STATE OF MAINE  
DEPARTMENT OF TRANSPORTATION  
16 STATE HOUSE STATION  
AUGUSTA, MAINE  
04333-0016

December 5, 2006  
Subject: **Orono**  
Project No. STP-1307(900)X  
Pin No. 13079.00  
**Amendment No. 1**

SPECIAL PROVISION  
SECTION 608

DETECTABLE WARNINGS FOR CURB RAMPS  
(Preformed Thermoplastic)

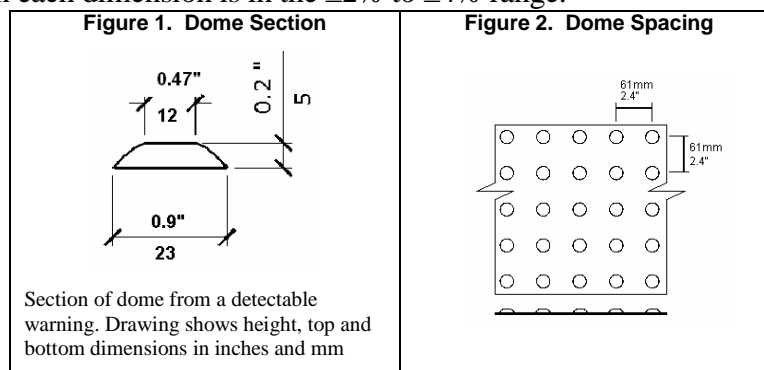
**Question:** Can you provide a detail for the Detectable Warning Plates?

(2) Geometry: The detectable warning material should meet the dimensions shown in Figures 1 and 2. The tolerance on each dimension is in the  $\pm 2\%$  to  $\pm 4\%$  range.

**Response:** See attached Special Provision Section 608.
